**CITY OF BELMONT
MEMORANDUM**

SUBJECT: September 4, 2012 Planning Commission Meeting – Agenda Item 5A
Application No. 2011-0055 – 49 Ralston Ranch Road
Single Family Design Review

11 Tree Map Scan

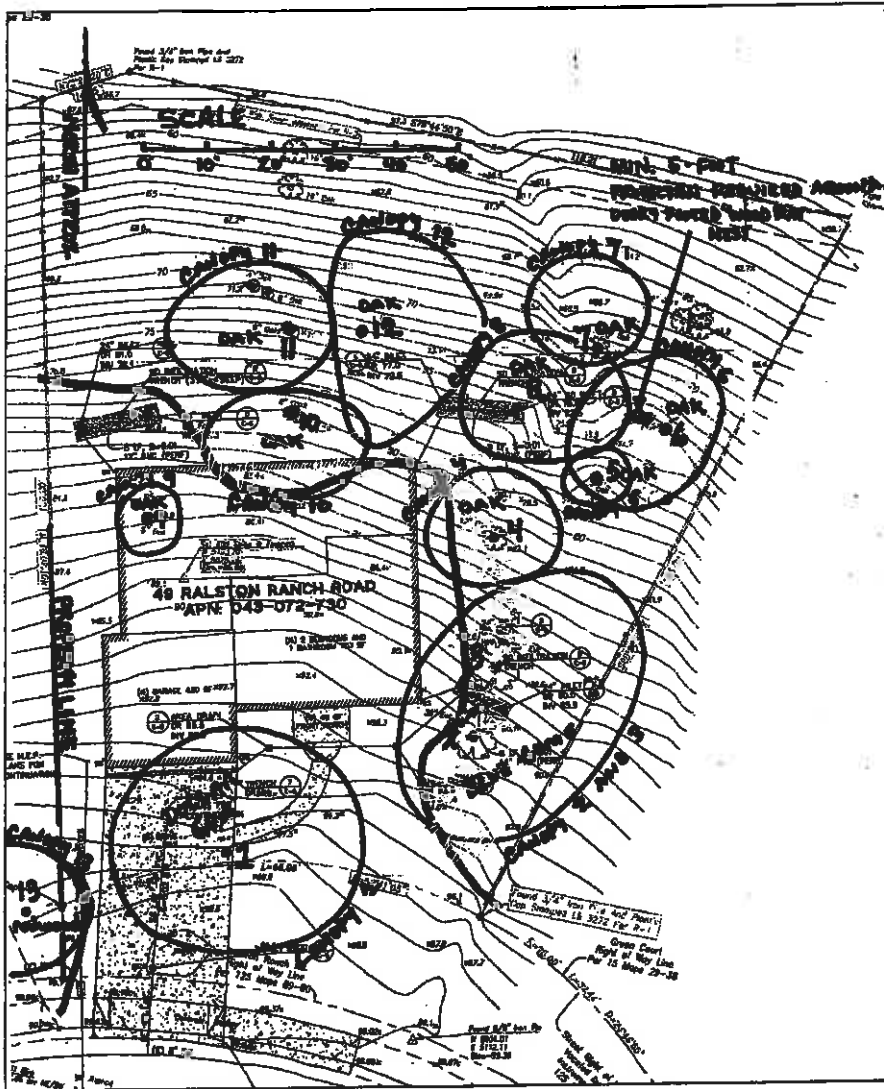
Note that the City Arborist-recommended fence routes as shown above are in direct conflict with the currently-proposed stairs, landscaping, deck, roofline, and storm drain infiltration trenches. Tree #10 will be considered a removal and fees will apply, if the proposed covered deck is built per current configuration.
